# **SUNDRY NOTICES AND REPORTS ON WELLS**

#### Dale H. Parke B Tract C #18 Deepening Program

# Premier Oil & Gas Inc. Dale H. Parke B Tract C #18 API 3001532397

# Closed Loop Operation & Maintenance Procedure

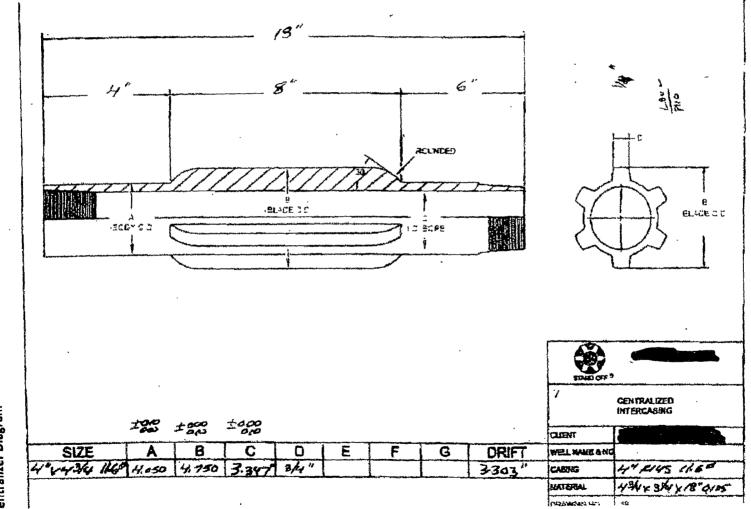
All drilling fluids are circulated over shakers and through steel work-over tanks.

Fines from shaker are dropped into stand by metal tank.

Additional tanks are used to capture unused drilling fluid or cement returns from casing jobs, as necessary.

At end of job, drilling fluid is disposed in a proper off location 3<sup>rd</sup> party injection well while fines are disposed of at a proper 3<sup>rd</sup> party waste disposal site.

- 2. Surface disturbance beyond the existing pad shall have prior approval.
- 3. A closed loop system is required. The operator shall properly dispose of drilling/circulating contents at an authorized disposal site. Tanks are required for all operations, no excavated pits.

Centralizer Diagram

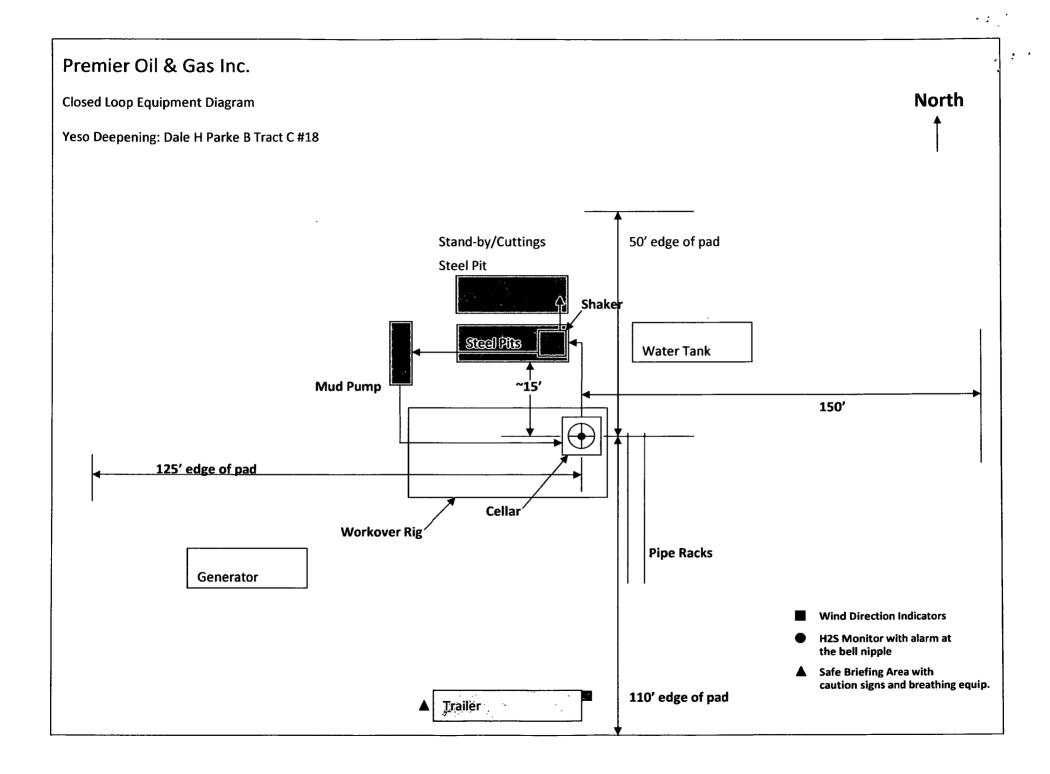
NOTE: Premier Oil & Gas Inc. requests a variance to the 0.422" stand-off rule between casing and wellbore.

Note: Premier Oil & Gas Inc. requests a variance to pressure test because the deepened well will be completed in the same zone as the current perfs and the entire interval is recognized by the OCD as one interval (Yeso). Otherwise, casing program will implemented per Onshore Order No. 2 Sect III: Requirements, Part B. Casing and cementing requirements, Subpart b. with a minimum of 100 feet overlap. No test shall be required for liners that do not incorporate or need a seal mechanism.

Fixed blade stabilizer subs will be utilized in the casing string to insure adequate isolation and seal throughout the wellbore. These stabilizer subs are positive fixed blade type. These subs will actually be screwed into the casing string. A diagram of the fixed blade stabilizer sub is located at the end of this program.

- 6. Variance for stand-off of less than 0.422" is approved due to NMOCD classifying the formations in the area as the Yeso group,
- 7. Approved for a minimum tie back of 100 feet. When plugged, a cement plug will be required across this tie back and across squeezed perforations.

- 8. Variance for not testing the liner seal is approved based on NMOCD classification of formations in this area as the Yeso group and provided stabilizer subs with positive fixed blades are utilized.
